Technical Service Bulletin

| Subject: VIBRATION FELT THROUGH FLOOR / SEAT / STEERING WHEEL AT APPROX. 25 - 30 MPH | Bulletin No.: 03-001/18 |
| | Last Issued: 06/05/2018 |

Parts Location:

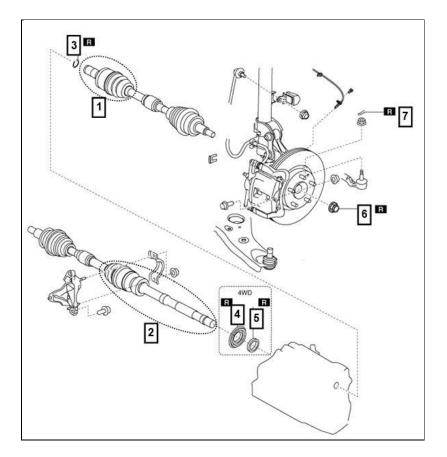
The vibration may be caused by wear on the inner surface of the tripod joint case (inner side of front drive shaft). To eliminate this concern, a coating has been applied to the inner surface of the tripod joint case to improve wear resistance.

1. Verify the customer concern. 2. Replace the inner joint set for the left and right drive shafts. Refer to MGSS online Workshop Manual:

- CX-5 FRONT DRIVE SHAFT REMOVAL/INSTALLATION and FRONT DRIVE SHAFT (TRIPOD JOINT) DISASSEMBLY/ASSEMBLY.
- Mazda6 FRONT DRIVE SHAFT REMOVAL/INSTALLATION and FRONT DRIVE SHAFT (TRIPOD JOINT) DISASSEMBLY/ASSEMBLY.
